TECHNICAL NOTE

Author:	Emily Scott - Holt; Paul Mew
Date:	13/07/2015
Project:	PI 364: 45 Maresfield Gardens
Subject:	Pedestrian Sightlines

P1364: 45 Maresfield Gardens, London
 Figure 1.
 Proposed Forecourt Parking

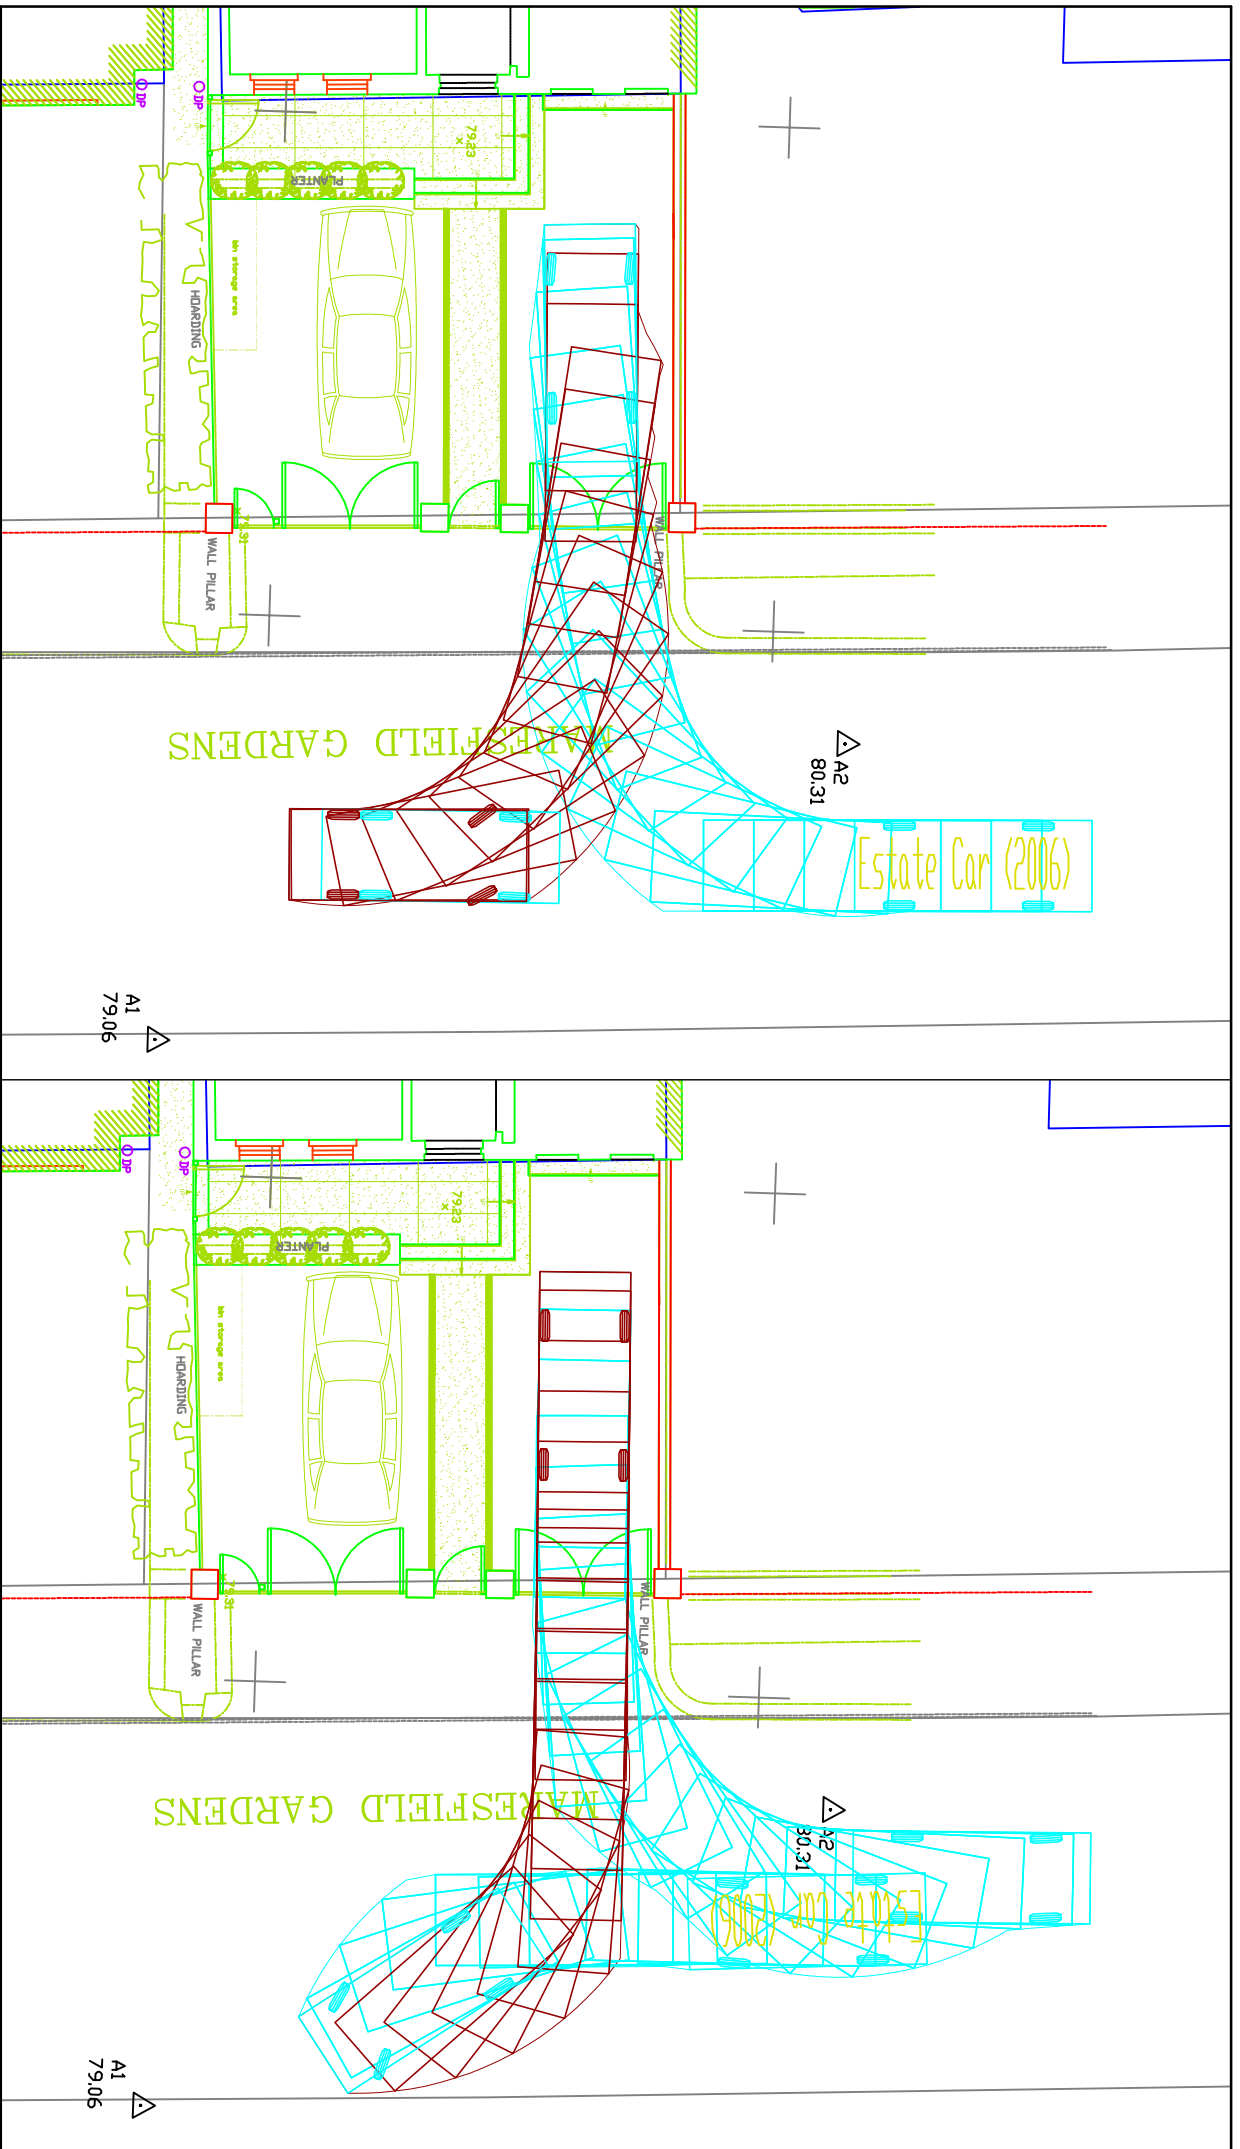
The proposed development includes dividing the existing parking spaces into left and right sides with a footpath in between. The right hand side parking space is located immediately adjacent to the northern boundary wall with number 45 such that there is no longer a visibility gap to the north. Moving the formerly central bay northwards results in the parking space no longer being aligned with the crossover. Vehicles using this bay therefore have to illegally cross the footway without the benefit of a full width crossover.

The proposed/implemented arrangements raise safety concerns with regard to the lack of visibility of the right hand (northern) parking space for pedestrians approaching from the north. As the space no longer aligns with the crossover pedestrians will not be expecting a vehicle to suddenly appear from behind the boundary wall. This is a particularly sensitive pedestrian route, with high numbers of vulnerable road users (school children) travelling to and from South Hampstead High School at the southern end of Maresfield Gardens at the start and end of the school day. The proposal is therefore contrary to Development Policy DPI9 parts a) and b).

The implemented arrangements raise safety concerns with regard to the lack of visibility of the right hand (northern) parking space for pedestrians approaching from the north. The space doesn't align with the crossover and as such pedestrians would not expect a vehicle to suddenly reverse from behind the wall.

In summary, we object to the proposed parking arrangements and the alterations that have already been made to the front boundary. The central brick pillars and gate posts that have been installed should be removed and the previous parking arrangements reinstated, i.e. with left and central parking bays so that they align with the existing crossover.

7. Figure 1 presents the location of the proposed northern parking bay.
8. Swept path analysis has been performed on the location of the proposed northern parking bay to confirm that a vehicle can enter and exit the parking bay. The results of the swept path analysis are presented in Figure 2 and demonstrate that the northern parking bay is accessible in forward and reverse gear.

9. To accommodate the proposed location of the northern parking bay the drop-kerb in front of the site will need to be extended to the north; reducing the permit holder only (PHO) parking bay by a maximum 3 metres.

10. The current total length of the PHO parking bay is 18 metres. In accordance with the Lambeth Methodology a distance 5 metres is considered to constitute a parking opportunity; therefore a reduction of the PHO parking bay by 3 metres to 15 metres will not result in a loss of parking opportunities on Maresfield Gardens.

24. The provision of reduced vehicle to pedestrian sightlines at the northern parking opportunity at 45 Maresfield Gardens is considered to be satisfactory, given the wide width of the footway and the low frequency of pedestrian movements along the footpath. In addition any vehicles exiting the site will exit at lower speeds given the reduced visibility, helping to increase pedestrian safety.
